PRODUCT CHANGE NOTICE

1. TITLE IRHMS597160 Electrical Characteristics		2. DOCUMENT NUMBER FV5-C-20-0037
		3. DATE August 25, 2020
4. MANUFACTURER AND ADDRESS International Rectifier HiRel Products, Inc 205 Crawford Street Leominster, MA 01453		5. MANUFACTURER PART NUMBER See below for IR HiRel Part Numbers
		6. BASE PART NA
		7. NATIONAL STOCK NUMBER (NSN) NA
8. CAGE 69210	9. EFFECTIVE DATE August 25, 2020	10. GOVERNMENT NUMBER NA
11. POINT OF CONTACT Manufacturer's Representative or Account Specialist (978) 534-5776		12. DRAWING NUMBER NA
		13. SPECIFICATION NUMBER MIL-PRF-19500/713

IRHMS597160 [2N7550T1]

-100V, P-Channel TID Hardened MOSFET in a TO-254AA package

Change Figure 8 Maximum Safe Operating Area curve;

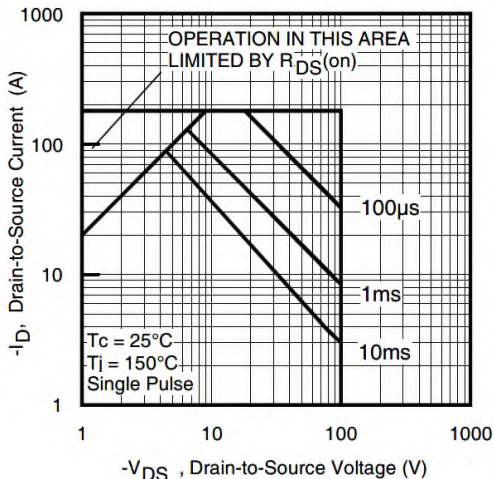
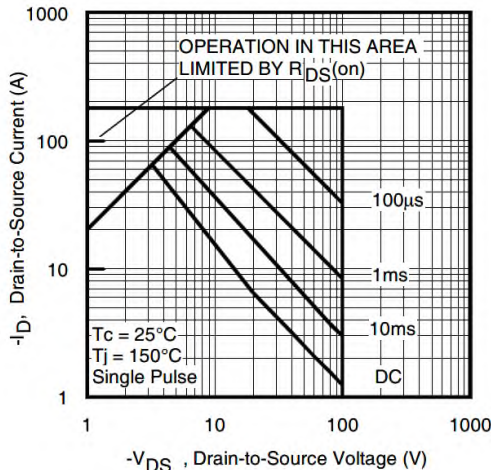
From:

To:
